Access Compliance Report

Public Rights-of-Way

Intersection ID: N/A	Main Street: S_CLARKSON_ST	Cross Street: DUNBAR_ST	Location: W
ADA ID: 0F64EBC8AC8A	Ramp Type: Perp	Initial Pass/Fail: Pass	Overall Compliance: No
		Severity Score: 0

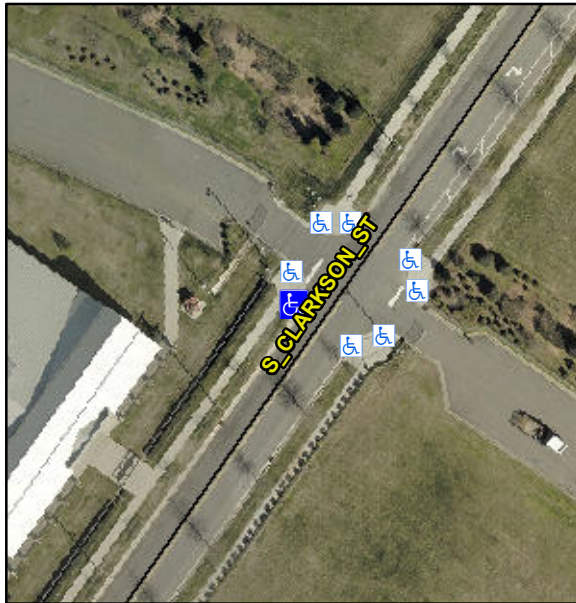
Not Found, R302.3, R402.2

Compliance	Description	Data	Compliance	Description	Data
N/A	Ramp Length (in)	96.0	Yes	Ramp Slope (%)	5.1
Yes	Ramp Width (in)	48.0	Yes	Ramp XSlope (%)	1.3
N/A	Flare Type LT	Sloped	N/A	Flare Type RT	N/A
N/A	Flare Slope LT (%)	5.2	Yes	Flare Slope RT (%)	5.9
N/A	Flare Traversable LT?	No	N/A	Flare Traversable RT?	Yes
Yes	Landing Length (in)	60.0	Yes	DWS Provided?	Yes
Yes	Landing Width (in)	48.0	Yes	DWS Contrast?	Yes
Yes	Landing Slope (%)	1.2	Yes	DWS Length (in)	24.0
Yes	Landing X Slope (%)	1.2	Yes	DWS Full Width?	Yes
N/A	Landing Curb? (Y/N)	No	Yes	DWS Offset (in)	1.5
N/A	Shared Landing?	No			
Yes	Gutter Ponding?	No	Yes	Gutter Slope (%)	1.1
Yes	Gutter Lip Ht (in)	0.0	Yes	Gutter X Slope (%)	0.8
N/A	Painted X Walk1?	No	N/A	Painted X Walk2?	N/A
	X Walk 1 Direction	To SE		X Walk 2 Direction	N/A
N/A	X Walk 1 Width (in)	N/A	N/A	X Walk 2 Width (in)	N/A
	X Walk 1 Slope (%)	2.3		X Walk 2 Slope (%)	N/A
	X Walk 1 X Slope (%)	1.4		X Walk 2 X Slope (%)	N/A

N/A	Ramp inside XWalk1?	N/A	N/A	Ramp inside XWalk2?	N/A
	Road Slope (%)	N/A	N/A	Clear Space?	Yes
	Road X Slope (%)	N/A	N/A	Clear Space to XWalk (in)	N/A
Yes	Any Obstructions?	Yes	Yes	Storm Grate/Utility Hazard?	No
	Obstruction Type			Storm Grate/Utility Type	
				PULLBOX LIP 0.5	N/A
			Yes	Surface Condition? (G/P)	Good

**Remove & Replace Entire Ramp.
Utility Present.**
